3. Nowag Tract Sigler Addition; KPB File 2024-043
Peninsula Surveying, LLC / Sigler
Location: East End Road
Fritz Creek Area / Kachemak Bay APC

ITEM #3 - PRELIMINARY PLAT NOWAG TRACTS SIGLER ADDITION

KPB File No.	2024-043
Plat Committee Meeting:	May 13, 2024
Applicant / Owner:	Gray and Barbara Sigler of Homer AK
Surveyor:	Jason Schollenberg / Peninsula Land Surveys
General Location:	East End Rd Milepost 6 Kachemak Bay APC

STAFF REPORT

NOWAG TRACTS SIGLER ADDITION

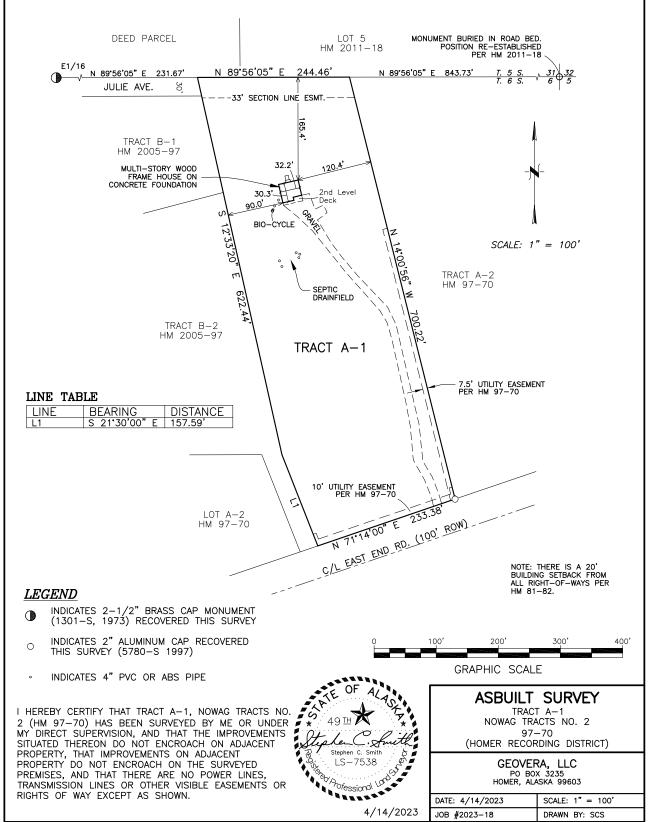
In the legal description, Lot A-1 should be corrected to Tract A-1

The length on the cul-de-sac on the east should be 453.85'

Tract to the south should be HM 74-1199. It is also in the process of being subdivided. Prior to finalizing and recording this plat, the status of that lot should be verified for change of information. Lot A-2 to the east should be changed to Tract A-2.

The plat is split between two designated wetland types: Discharge slope and Wetland/Upland Complex. Neither are shown or indicated on the drawing and they should be.

20' setback along East End Road is per 97-70 and should be noted.

Show survey data

Add a Certificate of Acceptance with dedication to the Kenai Peninsula Borough for Johnna Circle Add the date of May 13, 2024 to the Plat Approval

Staff recommendation: comply with 20.60.200 Show found and set monuments Show survey data Tie to GLO / BLM monuments
